REQUEST

Current Zoning: N1-A (neighborhood 1-A)
Proposed Zoning: UR-2(CD) (urban residential, conditional)

SUMMARY OF PETITION

PLANNING STAFF REVIEW

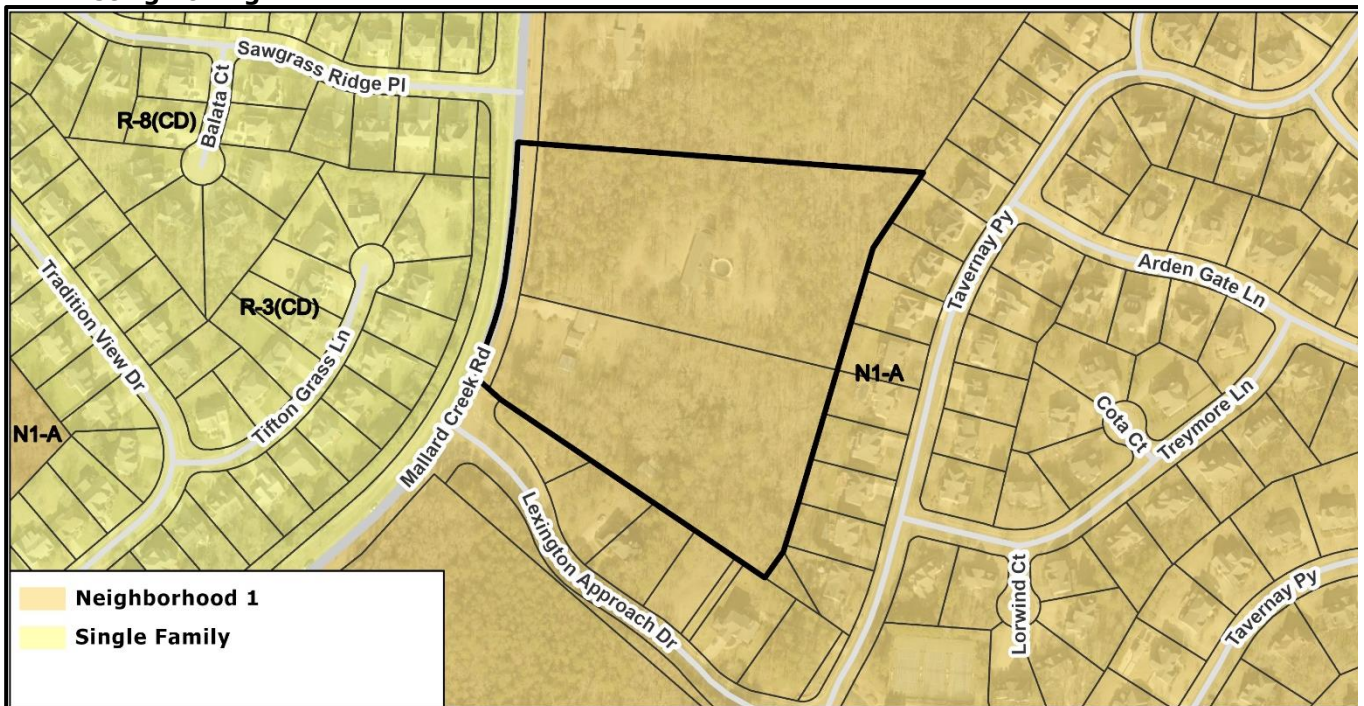
1. The site is served by CATS bus route #54. CATS requests the construction of ADA compliant bus standard detail 60.02A, 50 feet beyond the development entrance. The final location will be coordinated with the developer during the Land Development plan review process. **Addressed**
2. Site and Building Design
3. Reduce unit count and number of buildings with a mix of single family, duplexes, and triplexes to be consistent with the Neighborhood 1-Place Type. **Addressed**
4. Limit architectural note 5 to a maximum of 3 units per building along Mallard Creek Road. **Addressed**
5. Provide visitor parking spaces. **Addressed**
6. Limit height to 40 feet. **Addressed**
7. Add a street connection to the parcel to the north. **Addressed**
